This document was prepared by Yong Kim and Geoff Garner.

Revision 2, July 19, 2011

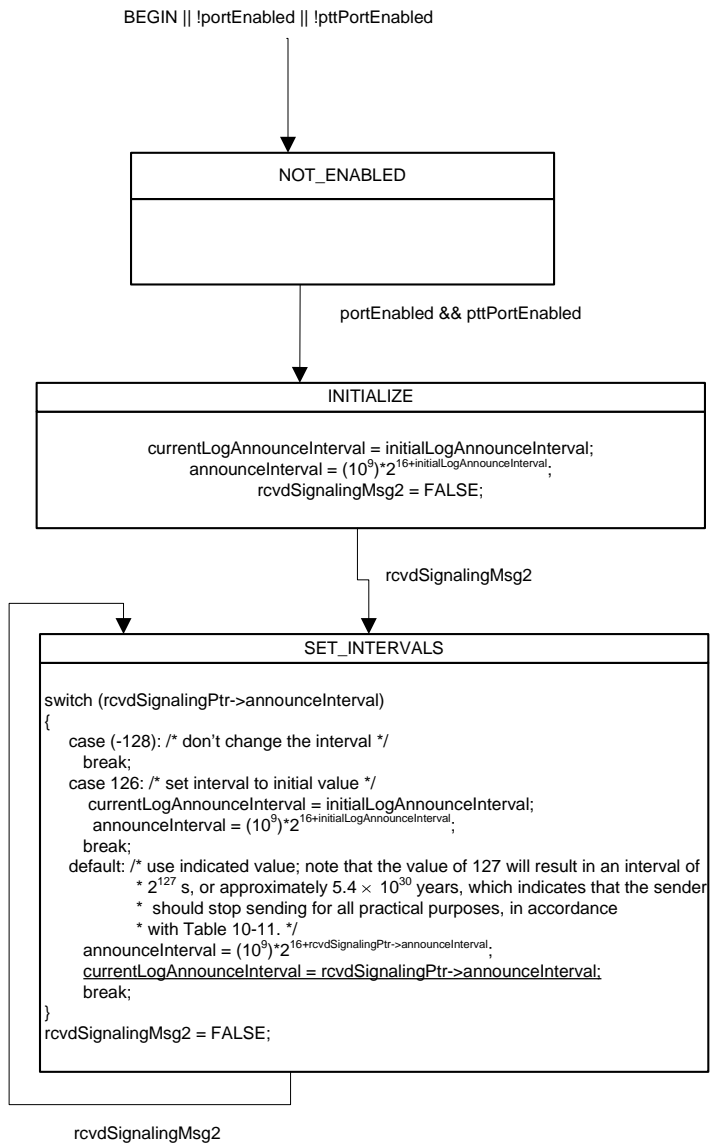
*Change the Figure of 10-16, as shown*

**Figure 11-2 – Transport of time-synchronization information**

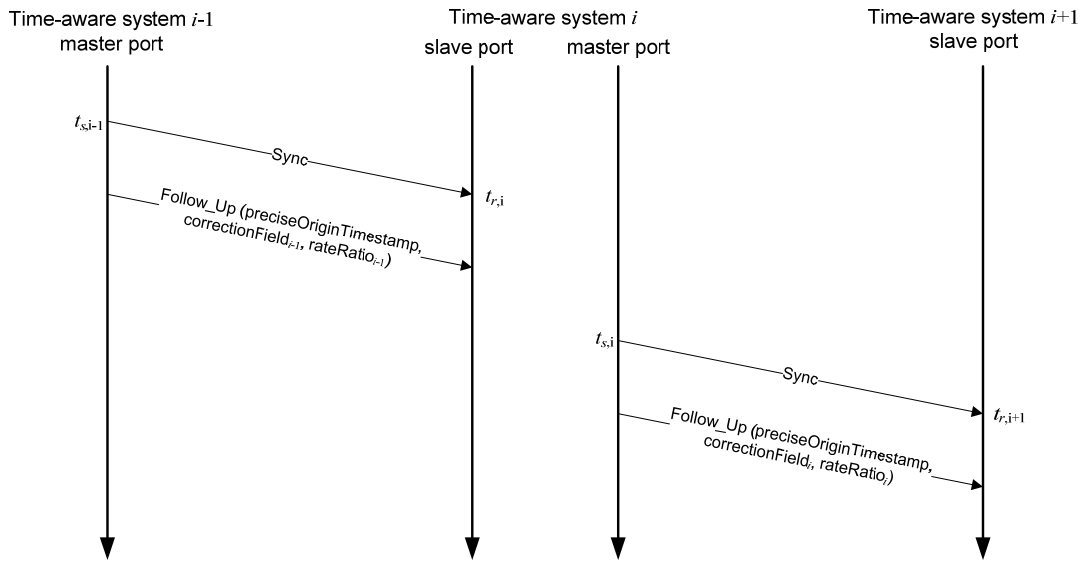
*Change the Text of 11.1.3, as shown*

The mean propagation delay on the link between time-aware systems  $i-1$  and  $i$ , relative to the LocalClock entity of time-aware system  $i-1$ , is equal to neighborPropDelay (see 10.2.4.7). This must be ~~divided~~ multiplied by rateRatio <sub>$i-1$</sub>  to express it in the grandmaster time base. The total propagation delay is equal to the mean propagation delay plus the quantity delayAsymmetry (see 8.3 and 10.2.4.8); delayAsymmetry is already expressed in the grandmaster time base. The residence time,  $t_{s,i}-t_{r,i}$ , must be multiplied by rateRatio <sub>$i$</sub>  to express it in the grandmaster time base.

**Figure B.3 – PTPDEV limit corresponding to wander generation requirement of Figure B.1**

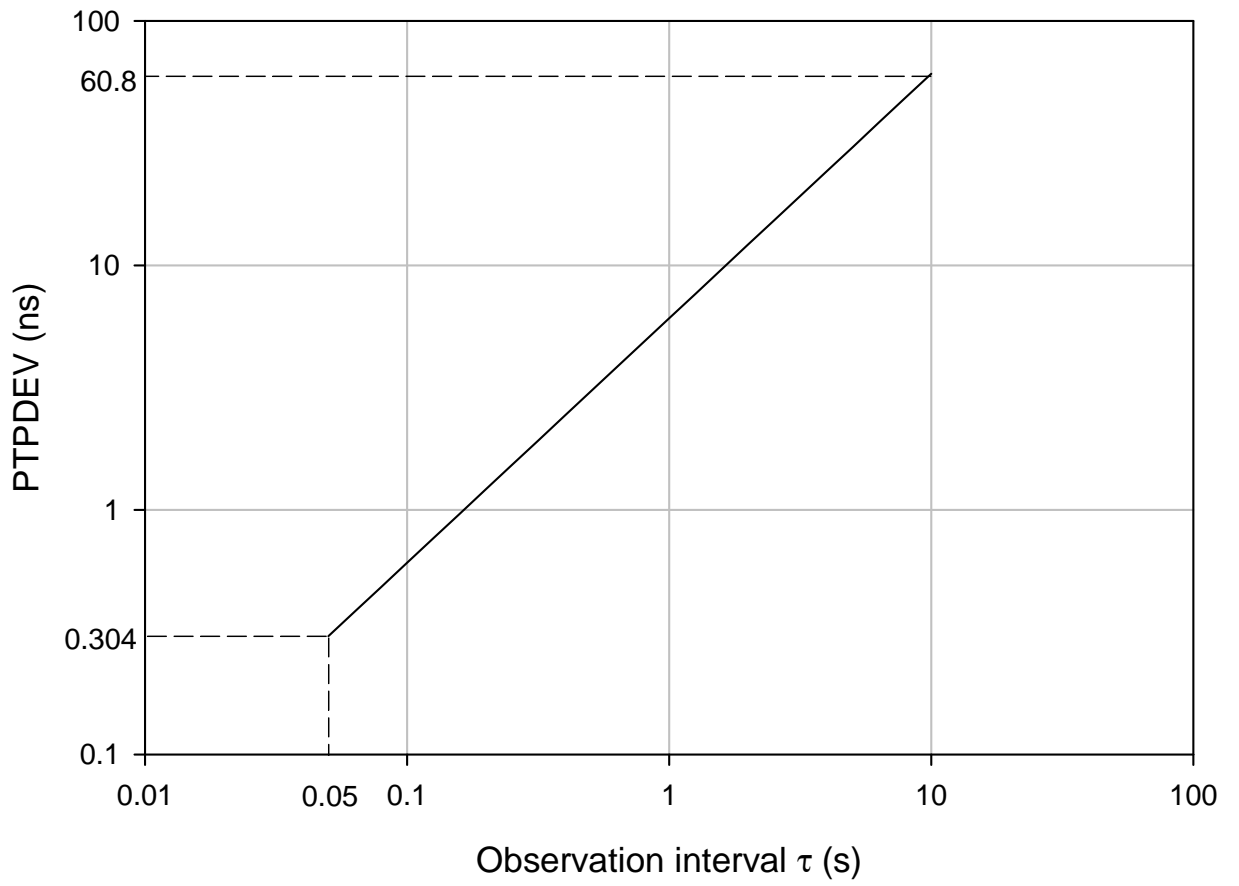
*Change the Text of B.1.3.2, as shown*

$$\sigma_{PTP}(\tau) = \sqrt{\frac{1}{6(N-2n)} \sum_{i=1}^{N-2n} (x_{i+2n} - 2x_{i+n} + x_i)^2} \quad , \quad n = 1, 2, \dots, \left\lfloor \frac{N-1}{2} \right\rfloor$$
